NAVIGATION - STALL WARNING HORN REPLACEMENT

MODEL	SERIAL NUMBERS
335	335-0001 thru 335-0065
340	340-0001 thru 340-0555
340A	340A0001 thru 340A1817

MEB-34-06
Page 1 of 25

Figure 1. 340 Before Modification (Sheet 1)

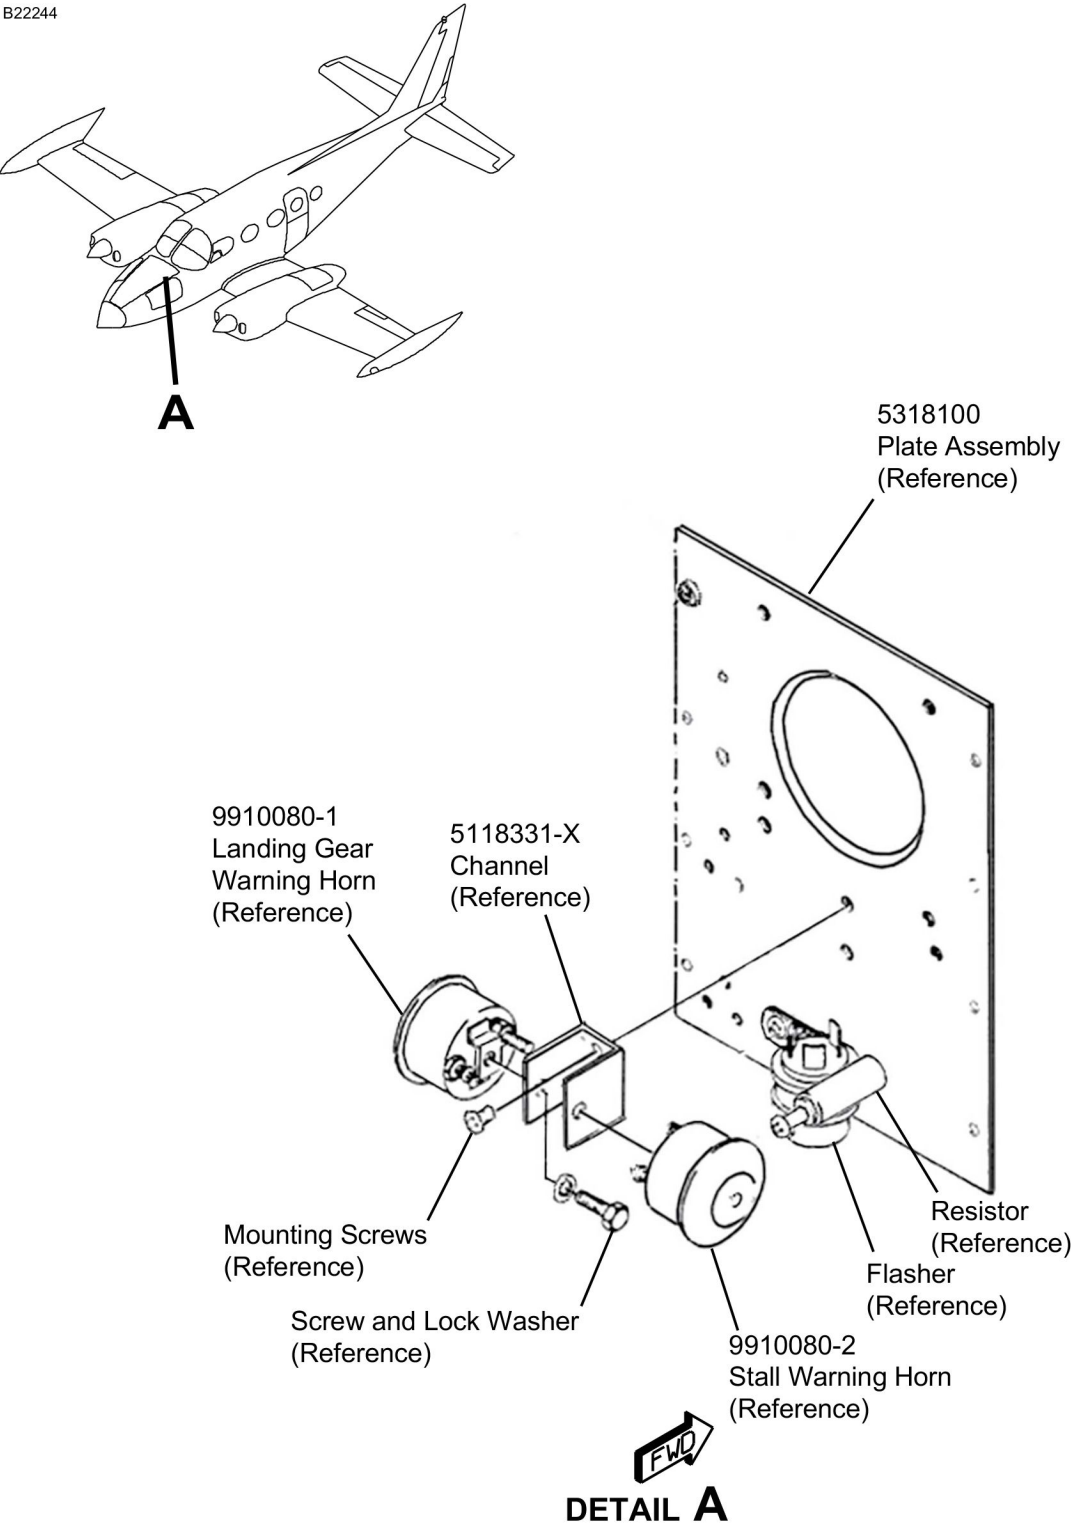
3. (For Model 340 Refer to Figure 1, Sheet 1, and for Model 335/340A Figure 2, Sheet 1.) Remove the 9910080-2 Stall Warning Horn as follows:
- A. Remove and discard the screw and lock washer from the 9910080-1 Landing Gear Warning Horn.
 - B. Disconnect and label the electrical wiring from the 9910080-1 Landing Gear Warning Horn.
 - C. Discard all electrical hardware from the 9910080-1 Landing Gear Warning Horn.
 - D. Discard the 9910080-1 Landing Gear Warning Horn.
 - E. Remove and discard the screw and lock washer from the 9910080-2 Stall Warning Horn.
 - F. Disconnect and label the electrical wiring from the 9910080-2 Stall Warning Horn.
 - G. Discard all electrical hardware from the 9910080-2 Stall Warning Horn.
 - H. Discard the 9910080-2 Stall Warning Horn.
 - I. Remove and keep the mounting screws from the 5118331-X Channel.

Figure 3. 340 Configuration 1 (Sheet 1)

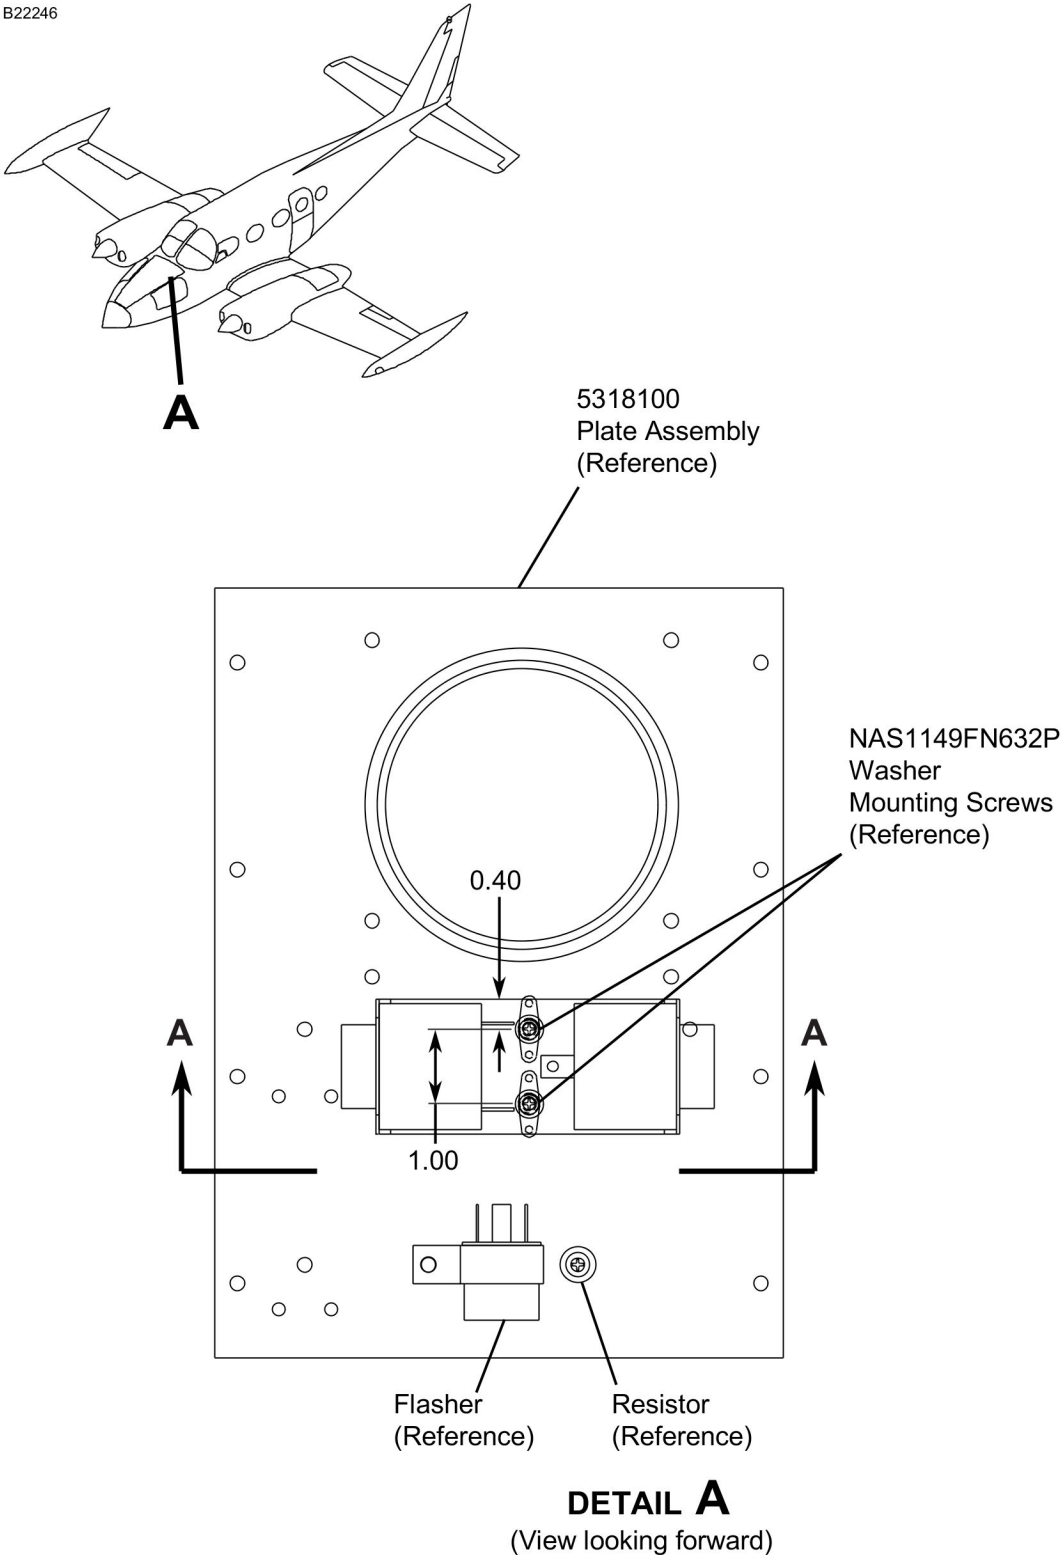
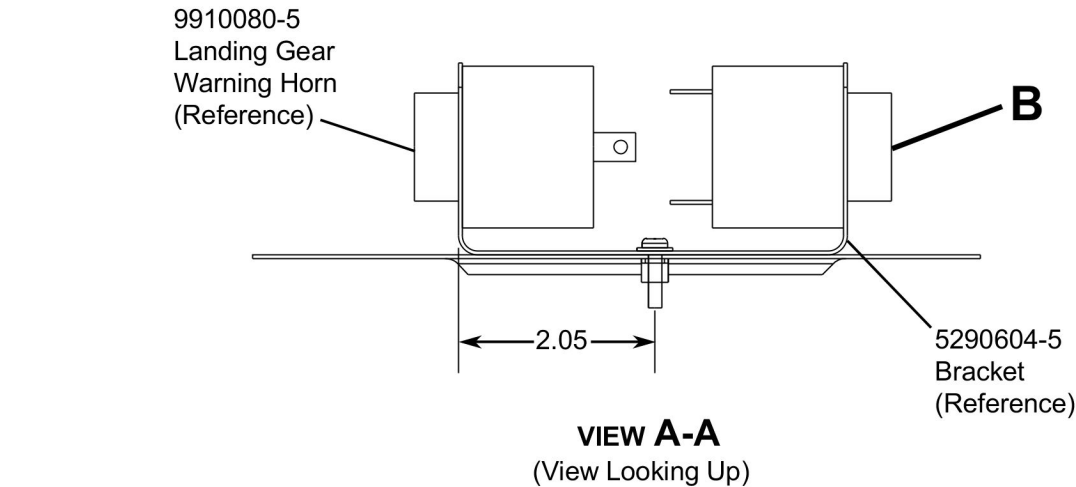
4. (For Model 340 Refer to Figure 3, Sheet 1 and 2, and for Model 335/340A Figure 4, Sheet 1 and 2.) Install the 9910080-6 Stall Warning Horn as follows:

- A. Install the 9910080-5 Landing Gear Warning Horn. (Refer to MEB-32-02: Landing Gear Warning Horn Replacement, **CONFIGURATION 1**.)
- B. Install the 9910080-6 Stall Warning Horn into the 5290604-5 Bracket.
- C. Install the knurled nut onto the 9910080-6 Stall Warning Horn.

NOTE: The plastic knurled nut must be installed with the three indents toward the bracket and horn assembly. On the internal circumference, the smooth side without threads is installed first, towards the bracket and horn. This technique of installation will make sure the nut fully seats against the bracket and not bottom-out on the threads. If not installed correctly the knurled nut will bottom-out on the threads and the horn assembly will not be fully tightened in the bracket.

Figure 5. 340 Configuration 2 (Sheet 1)

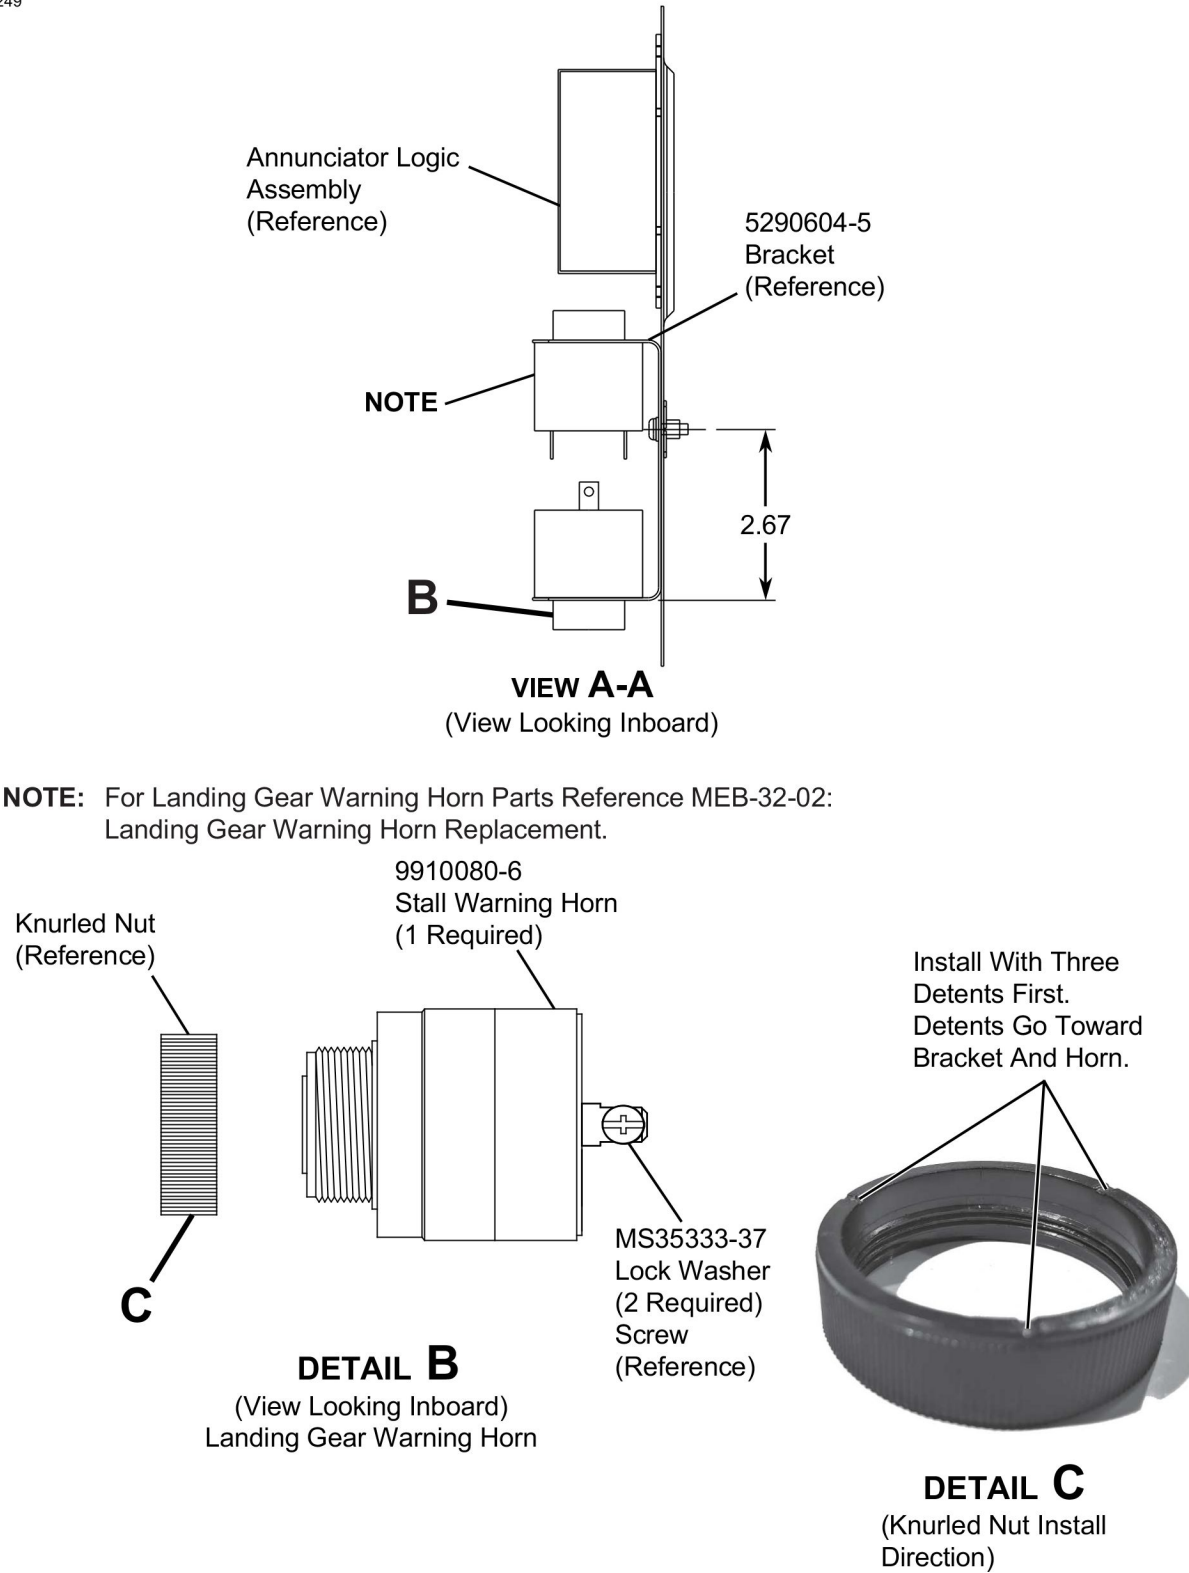
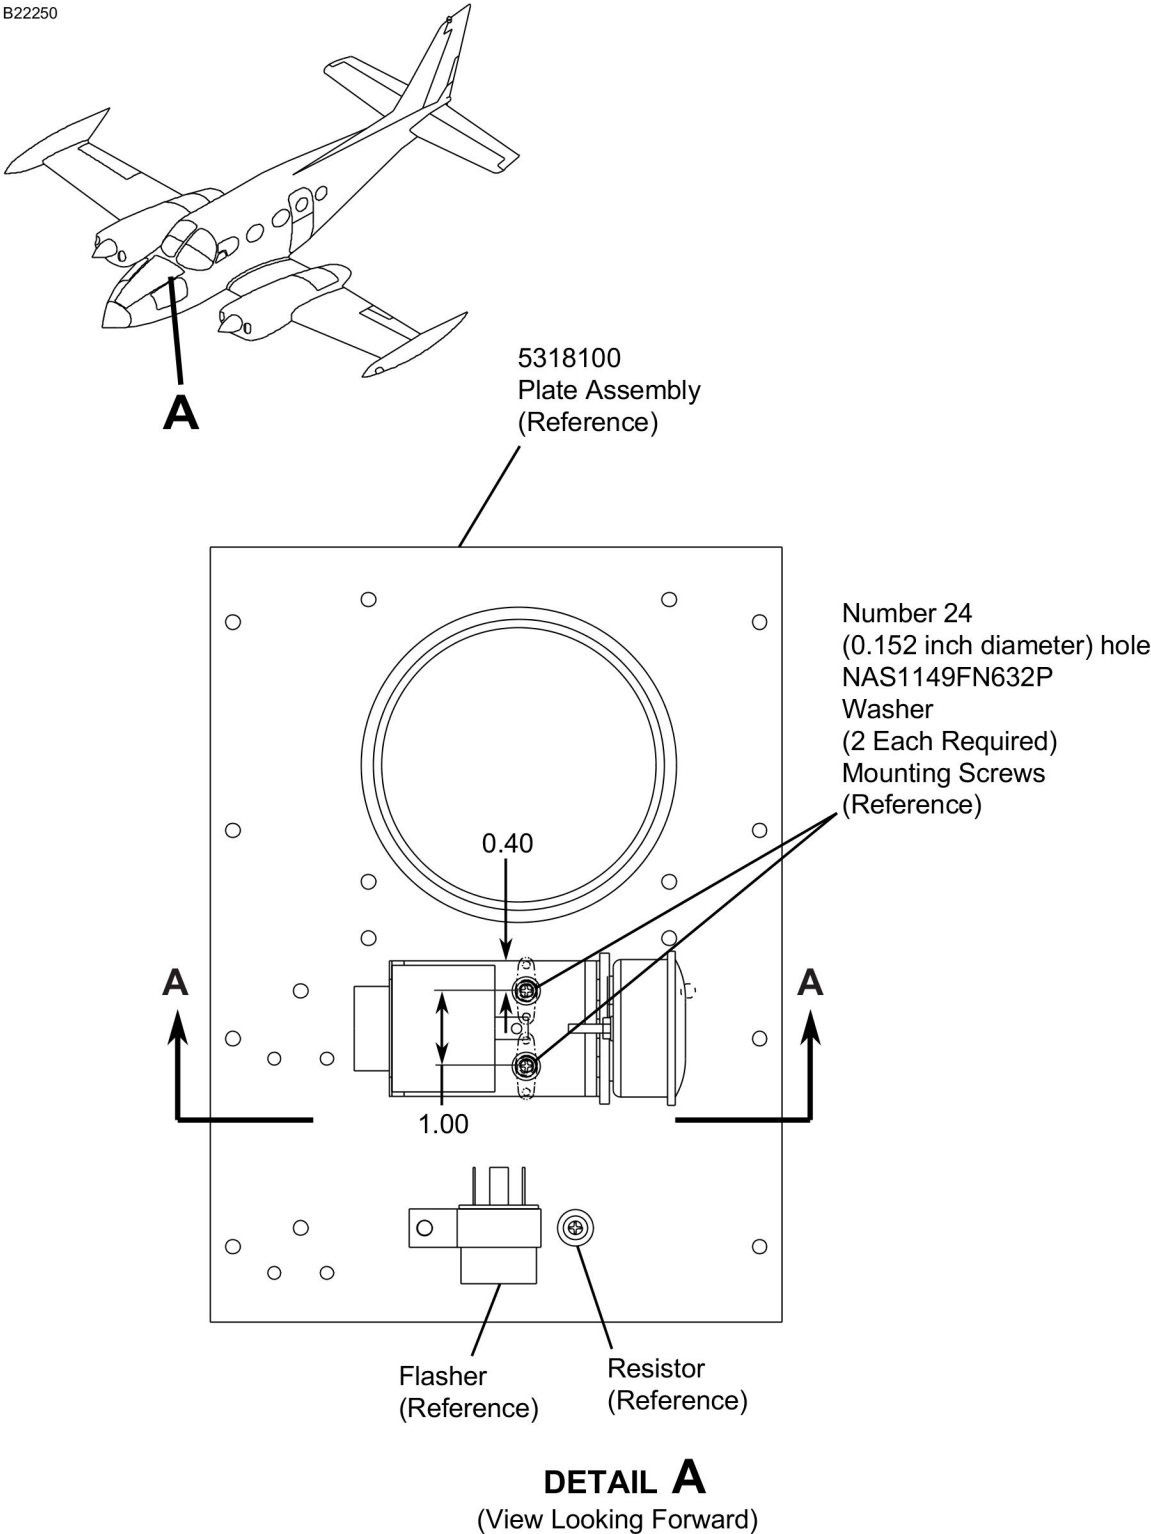
NOTE: The kept mounting screws will be used during installation.
 - H. Discard the 5118331-X Channel.
8. (For Model 340 Refer to Figure 5, Sheet 1 and 2, and for Model 335/340A Figure 6, Sheet 1 and 2.) Install the 9910080-6 Stall Warning Horn as follows:

- A. (For Model 340 airplanes.) Match drill the two Number 24 (0.152 inch diameter) holes of the 5318100 Plate Assembly to the 5290604-3 Bracket.
 - (1) Debur the drilled holes from the 5290604-3 Bracket.

- (2) Apply Color Chemical Film Treatment to all bare metal.
 - (3) Install the 5290604-3 Bracket with the two kept mounting screws and the two NAS1149FN632P Washers into the 5318100 Plate Assembly.

- C. Install the 9910080-6 Stall Warning Horn into the 5290604-3 Bracket.
